Interactive comment on “The possible negative consequences of underground dam and reservoir construction and operation in coastal karst areas: an example of the HEPP Ombla near Dubrovnik (Croatia)” by T. Roje-Bonacci and O. Bonacci

T. Roje-Bonacci and O. Bonacci

Received and published: 24 May 2013

Fig. 1. New Figure 3

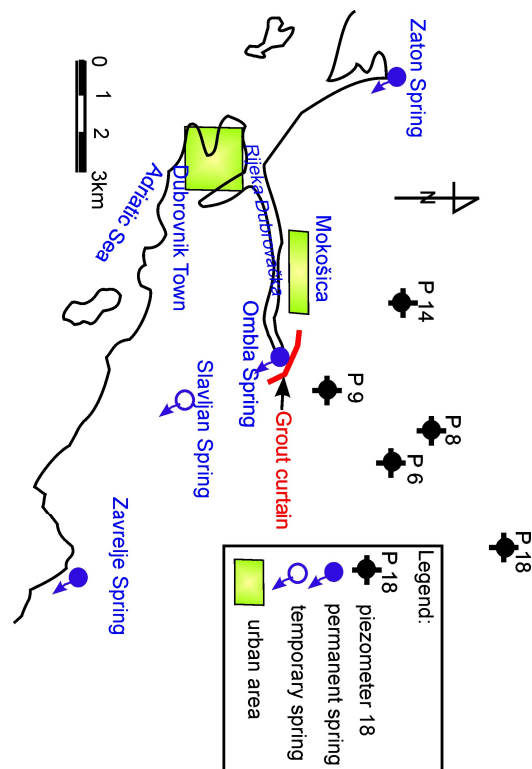
19) Fig. 3: piezometers in figure are five and not four; green boxes are not explained in

the caption. In Figure captions four is corrected by five, New Figure 3 with green boxes explanation is prepared.
